Rezoning Transportation Analysis

Petition Number: #2022-030

Date	Description
07-24-2022	First Review (AO)
09-21-2022	Second Review (AO)

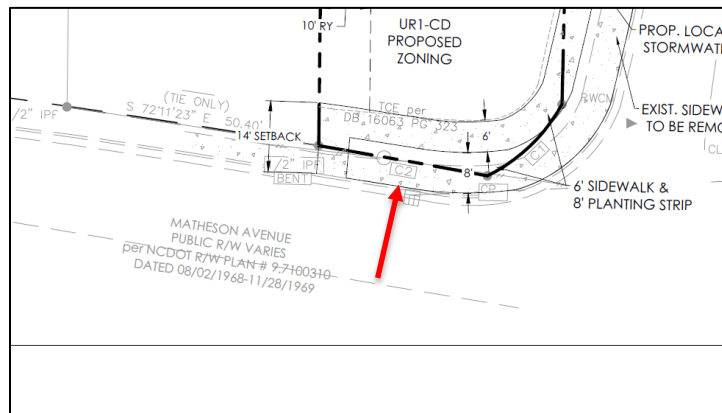
1. **Curblines:** The proposed zoning district has a setback measured from back of the existing or proposed future curblines.
 - a. **Matheson Avenue:** Curb and gutter to be 27-feet measured from centerline to back of curb.

Label and dimension the curb and gutter from the centerline for each road on the site plan.

Update to Comment (New Site Plan, 8-1-22): Label and dimension existing curblines location on site plan measured from centerline of Matheson Avenue.

3. **Outstanding Comment from 07-24-22:** Revise site plan and conditional note(s) to commit to dedicate 40-feet of right-of-way along Matheson Avenue measured from the road centerline. The site plan shall label and dimension the right-of-way from the road centerline.

4. Revise site plan and conditional note(s) to commit to construct an 8-foot planting strip, and 6-foot sidewalk on Matheson Avenue and Pinckney Avenue per Chapter 19. The site plan shall label and dimension both items from the back of curb and gutter.

Update to Comment (New Site Plan, 8-1-22): Add streetscape commitments to conditional notes section of the Rezoning Plan.

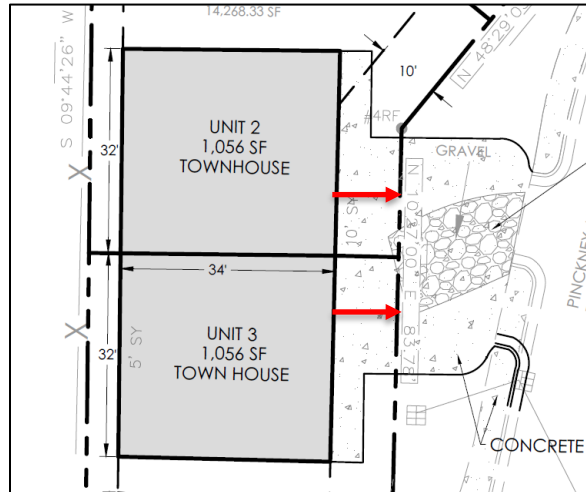
5. **Outstanding Comment from 07-24-22:** Revise site plan and conditional note(s) to show proposed intersection and frontage improvements of Matheson Avenue Road Conversion project project that is being done by the City's CIP project. These improvements can be shown as "by others" and in grayscale. The project scope includes converting Matheson Avenue from 4 lanes to 2 lanes, construct raised 2-way cycle track on south side of Matheson Avenue.

These improvements to be coordinated with General Services and CDOT during the permitting process.
